LVD Timing Diagram Correction

SPI-3R7 Figure 44 & 45 correction

Text Correction

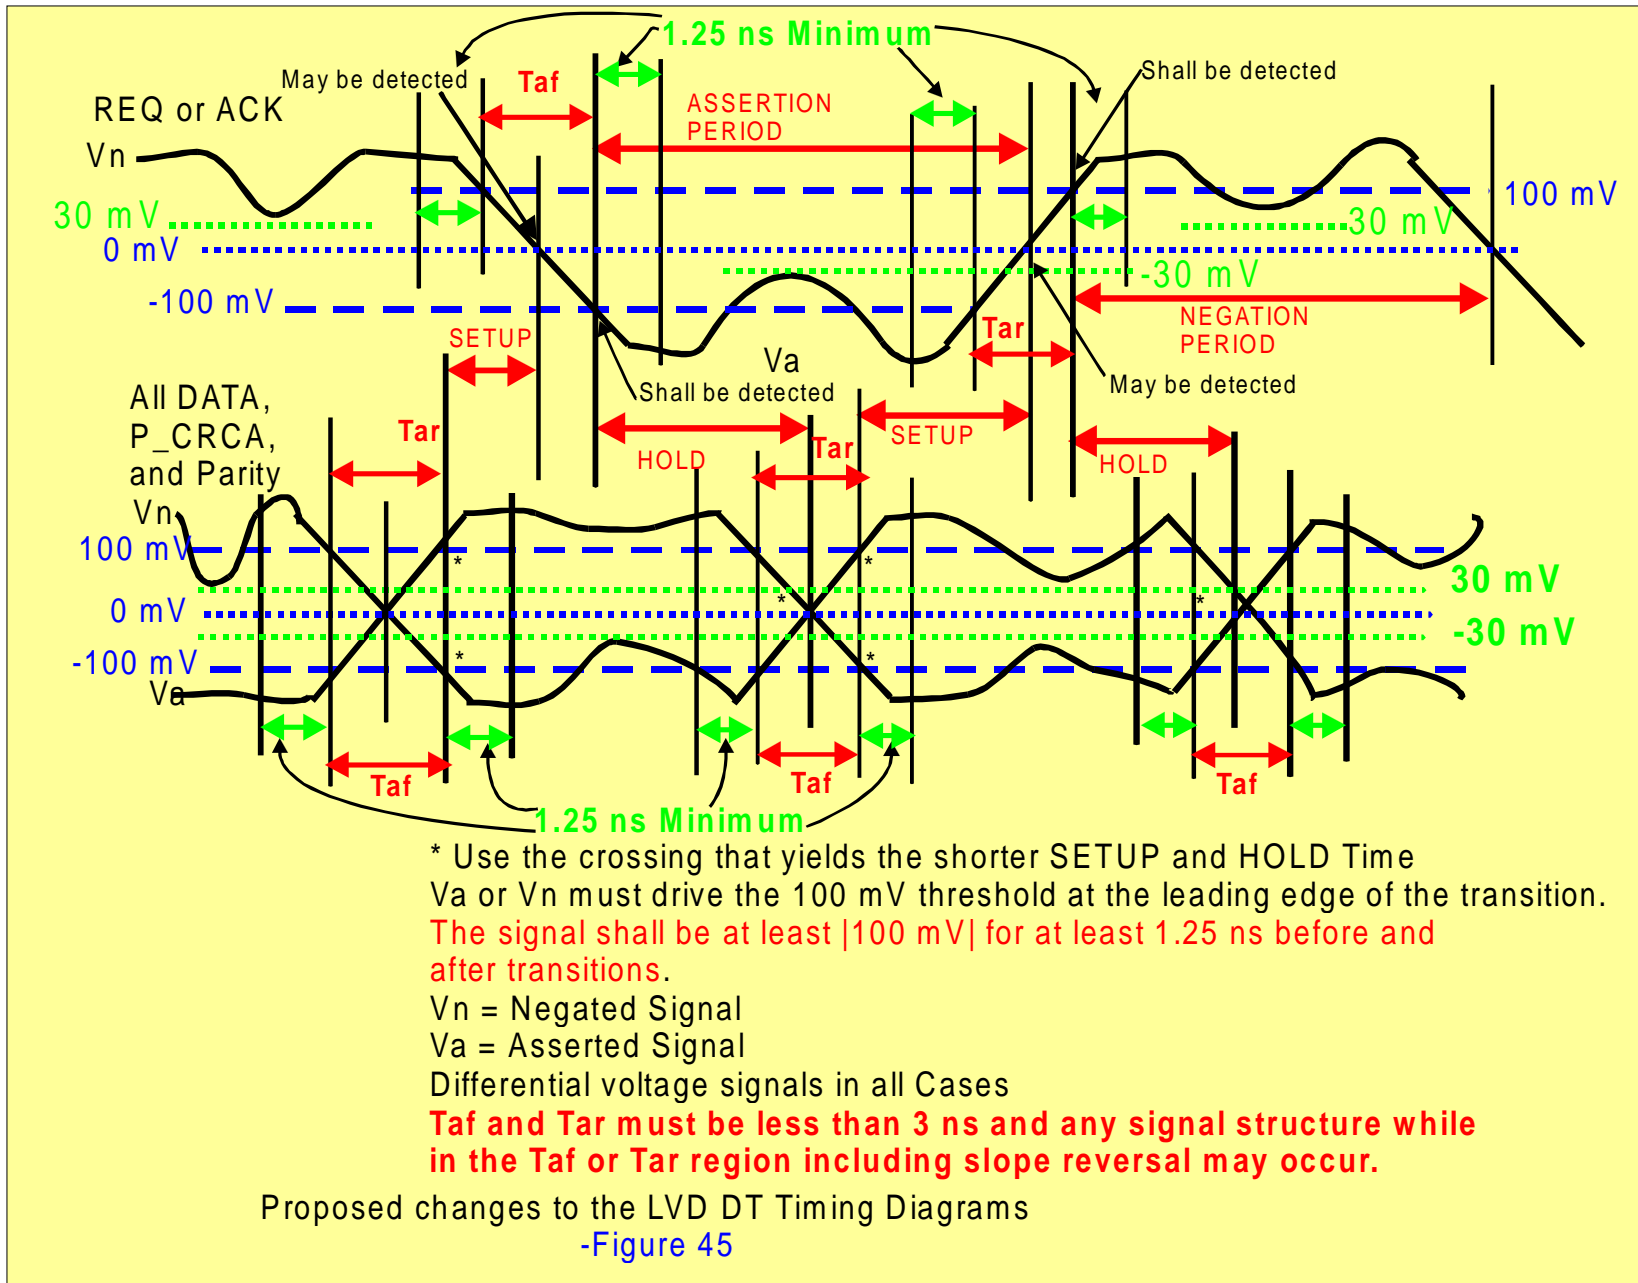
- 9.3.3 LVD Transfer Rates second paragraph Text Correction
- Figure 44 and figure 45 illustrates the signal must transition from -100 to 100 mV or 100 to - 100 mV in 3 ns, the waveform between -100 and 100 mV is not specified. Signals shall remain above the |100 mV| level for 1.25 ns at each end of the transition. The signals shall not drop below |30 mV| except during the transitions. Conditions exist with longer loaded SCSI busses and irregular REQ and ACK pulse widths where long assertions or negations produce a much larger signal than short assertions or negations. This sets up an environment where the short REQ or ACK pulses may not have adequate timing margin unless the definitions in figure 44 and 45 are used in the measurement of timing parameters.

Note: Blue is delete, red is add

Annex A Receiver Mask

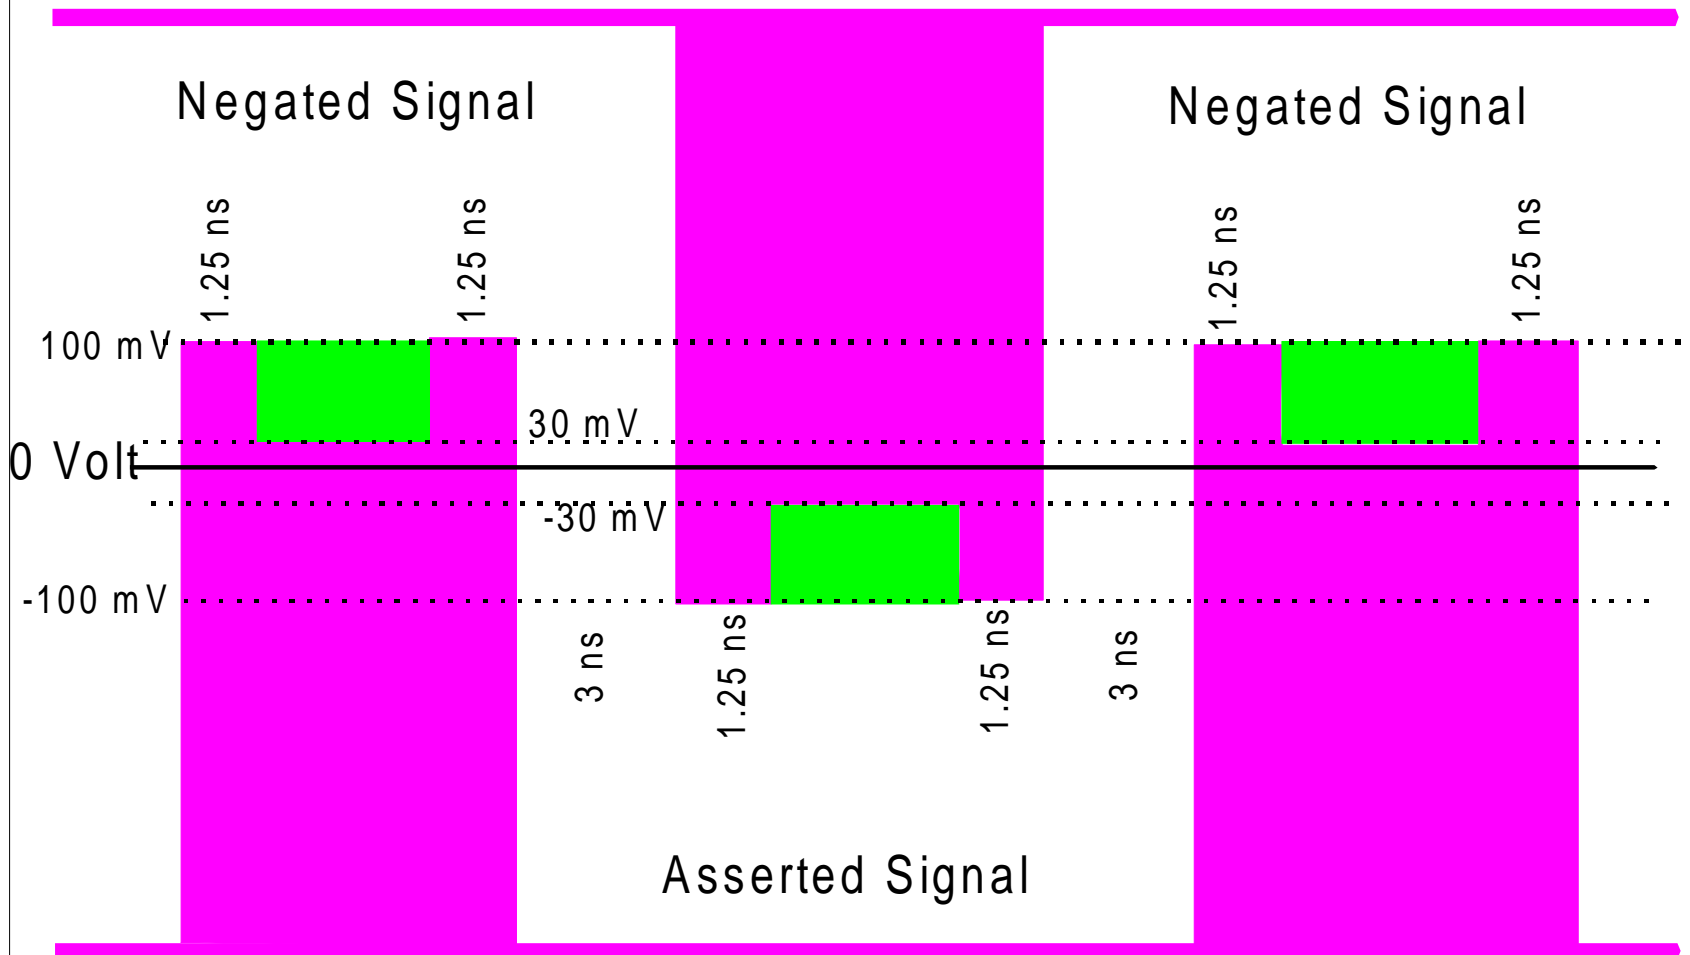
- Add a receiver mask for the allowable signal at the Receiving device connector.
 - Edges of transitions are require at least $|100 \text{ mV}|$ for 1.25 ns.
 - Signals are allowed to have noise inside the assertion or negation signal that drop back to $|30 \text{ mV}|$.

Receiver Mask, during the data transitions
 +/-1.1 volt maximum with reflections

Asserted to Negated signals must maintain a 4 to 1 average signal.
